Conservation Commission AGENDA

Thursday, April 23, 2026 - 6:00 PM

This memorandum has been prepared by BSC Group, Inc. on behalf of Agawam Energy Center, LLC in response to the peer review comments issued by Stockman Associates LLC on April 2, 2026, regarding the Request for Determination of Applicability (RDA) submitted for the proposed Agawam Energy Center Battery Energy Storage System (BESS) project at 769 Silver Street, Agawam, Massachusetts. This memorandum addresses the two areas identified during the March 24, 2026 joint site visit where additional evaluation was determined to be necessary. The findings of BSC Group's supplemental field investigation conducted on April 8, 2026 is included herein. Based on the totality of evidence gathered, BSC Group maintains that neither area constitutes a jurisdictional wetland resource area under the Massachusetts Wetlands Protection Act (WPA) or applicable federal regulations, and that the previously delineated resource area boundaries remain valid, as submitted in the RDA.

Figure 5. Timeline of historic imagery in the area. A red polygon is drawn approximately around the areas where moist conditions were observed to act as a reference point for comparing the sequence of aerial imagery. The date of the imagery is shown in the top left of each image.

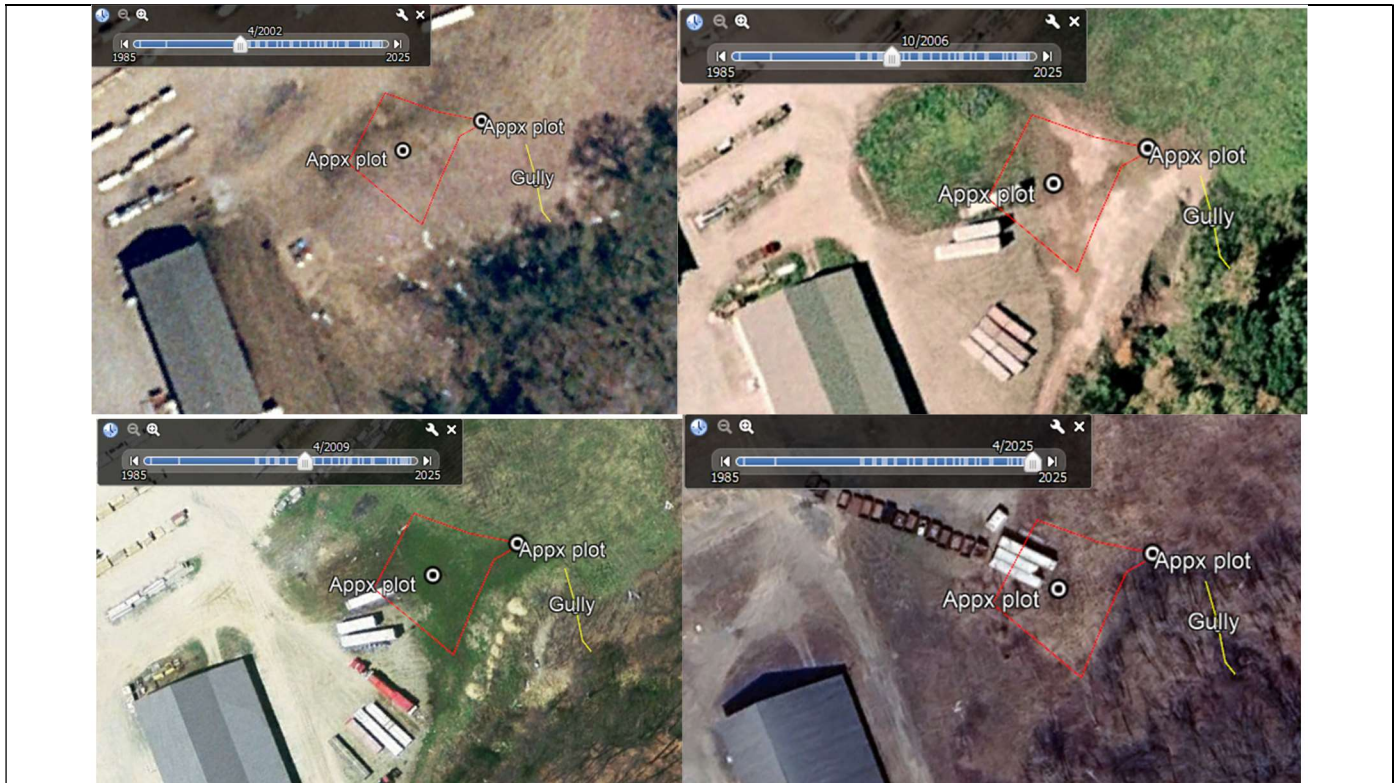
Upon review of available historic imagery in GoogleEarth™ (see Figure 5), it appears that this area in question was forested in 1990 and by 2002 the area was cleared of trees and there were no apparent indicators of hydrology on the aerial imagery. By 2006, this entire area was covered in fill material, and a very large pile of material was stockpiled in an approximately 230-foot line oriented north-south, creating an artificial berm restricting flow of runoff/stormwater. By 2009, the fill material may have been spread or relocated and most of the area revegetated, with a smaller stockpile/berm still remaining along the easterly side and some visible signs of soil saturation on the imagery. The alterations of this area indicate improper management of stormwater over the last decade or so and the area is likely artificially wet due to fill material causing an artificial restrictive layer and the berm, artificially impounding, slowing, or containing more water than would have otherwise occurred without these alterations. The gully was not visible on the 2002 imagery and may have formed after the fill was placed as it is positioned exactly at the northerly terminus of the 2006 stockpile.

GRADING PLAN - SHEET 1

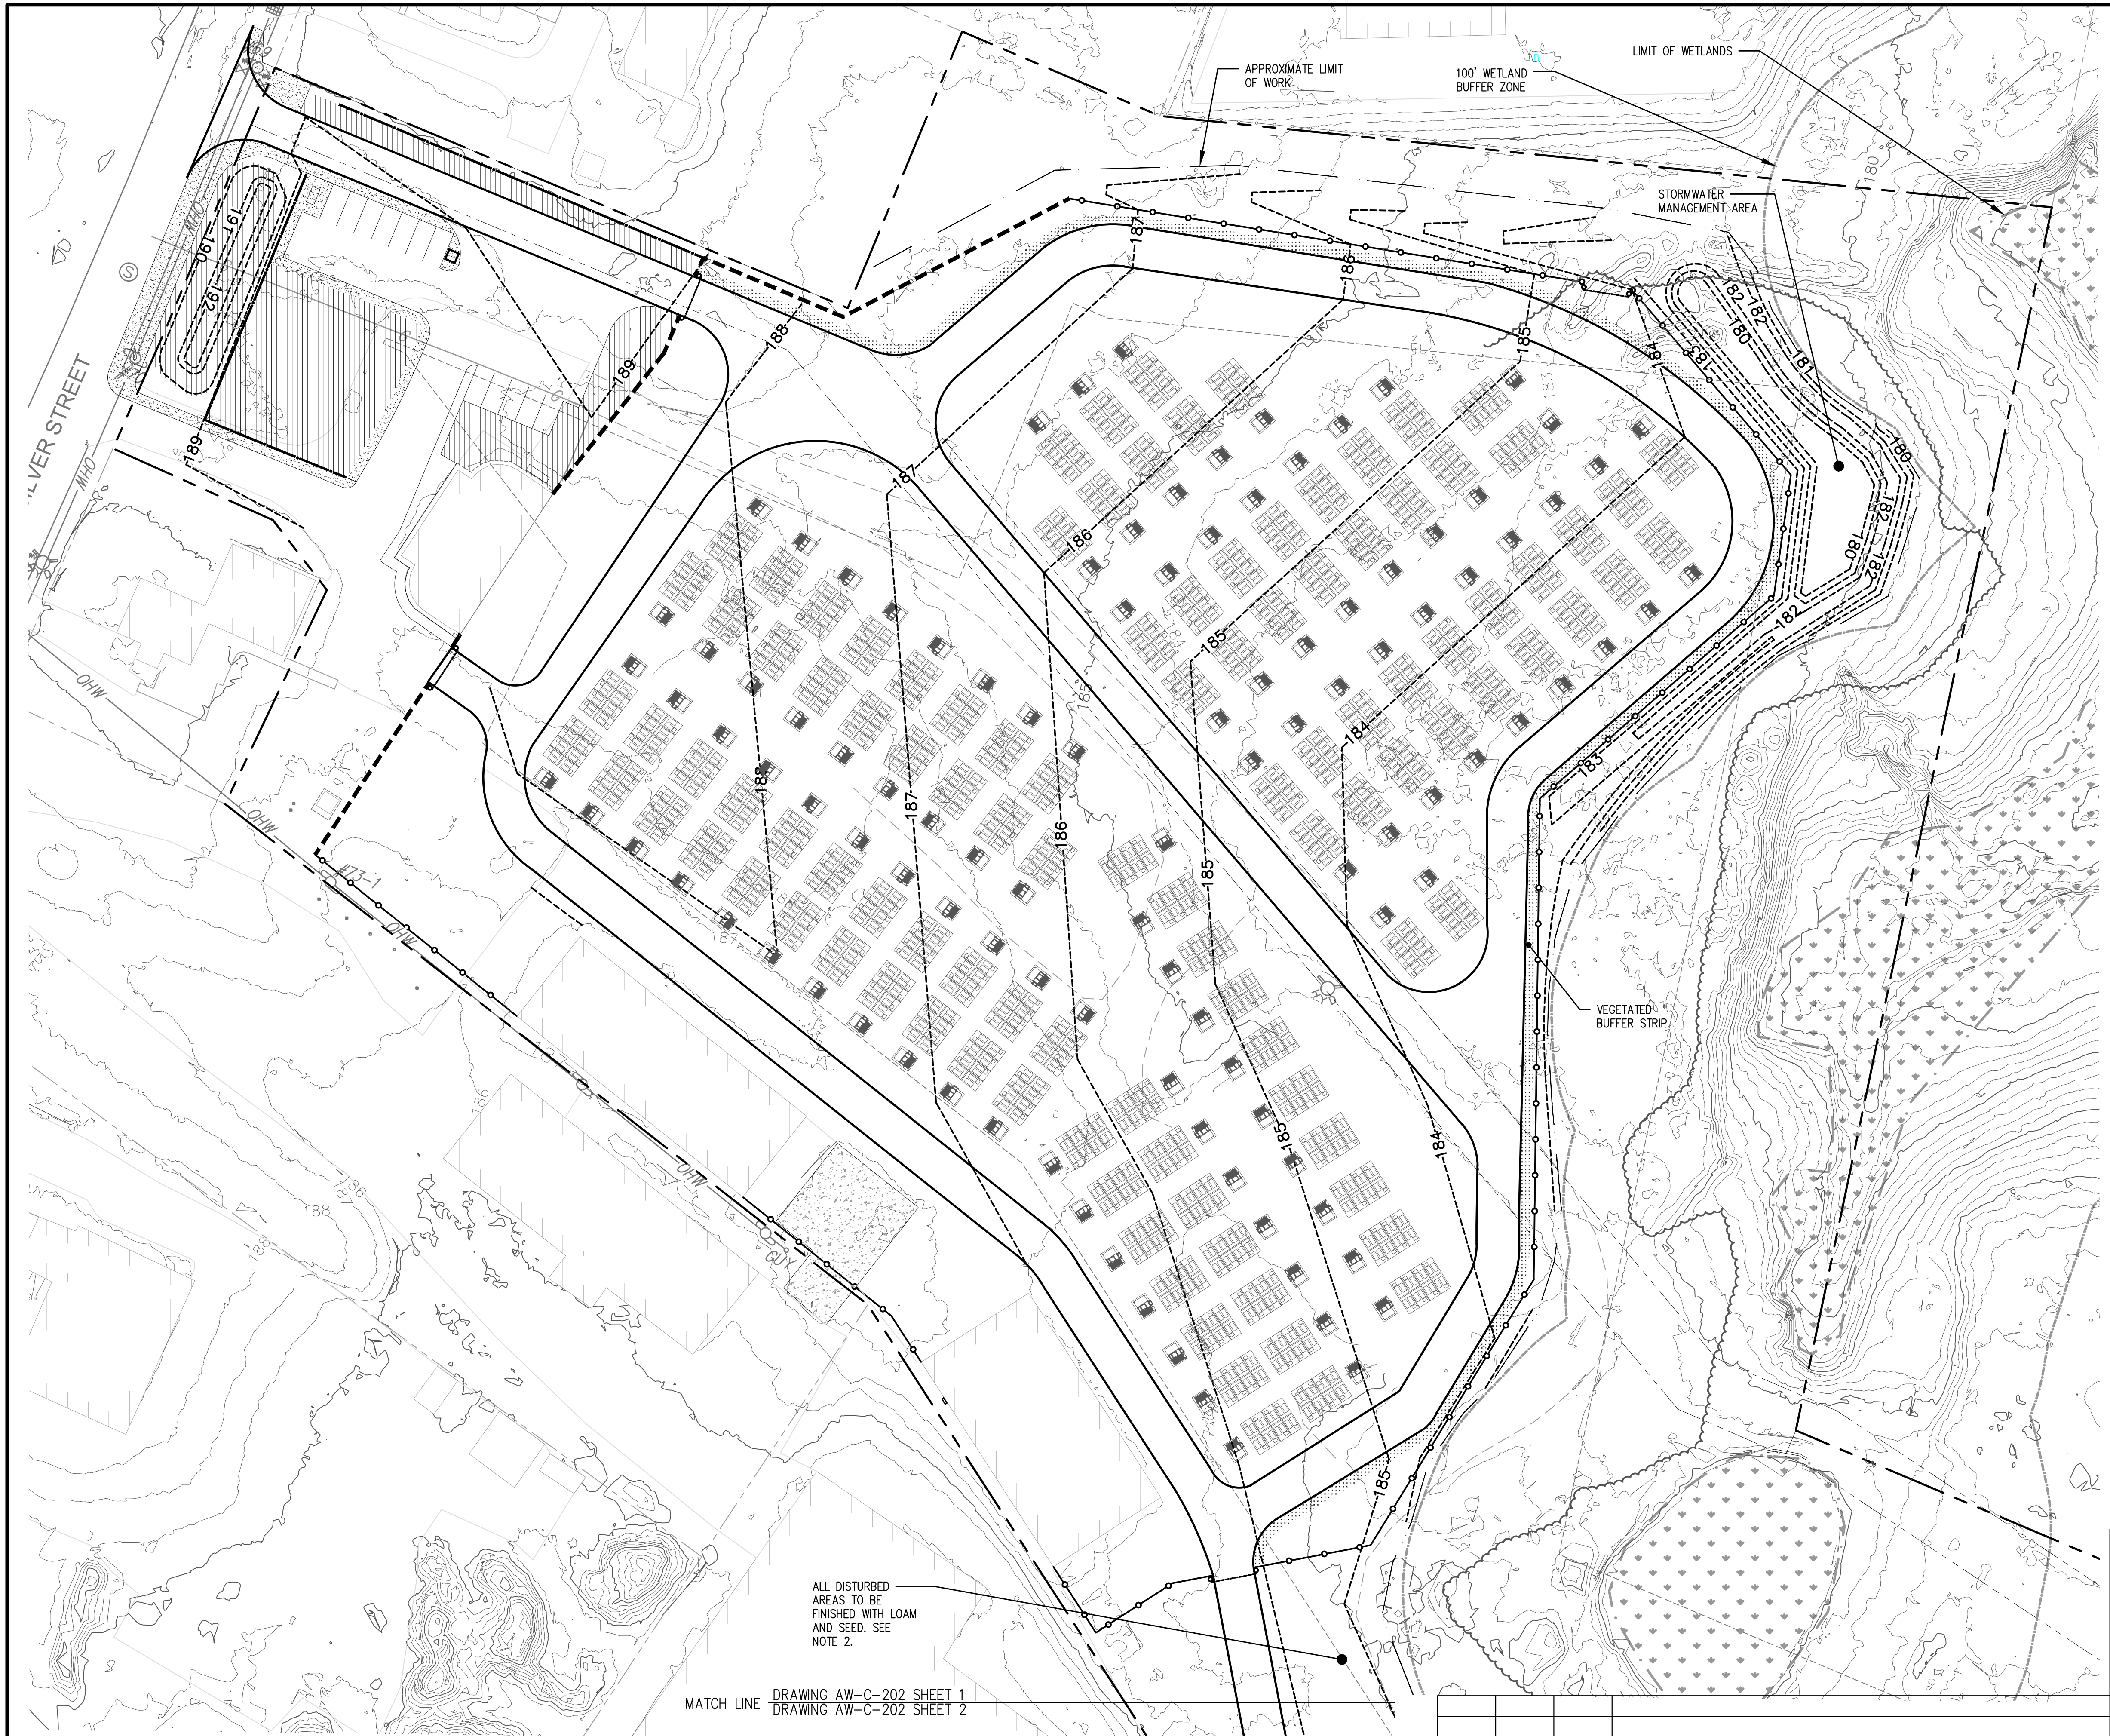
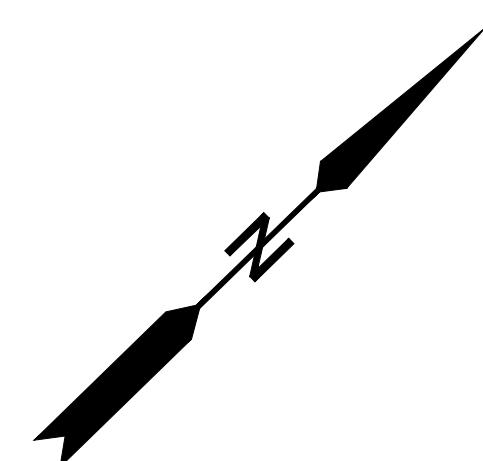
- a. Based on the easterly limit of work depicted on Grading Plan-Sheet 1, Stockman Associates suggests that the limit of work depicted on revised plans be carefully reviewed. Based on the close proximity of the depicted grading, limit of work, and Buffer Zone boundary, it appears that the installation of erosion controls may encroach into the Buffer Zone boundary. The Erosion And Sediment Controls Detail sheet indicates that the contractor will have the option to use sediment barrier (2-FT minimum width) or silt fence for slope protection.
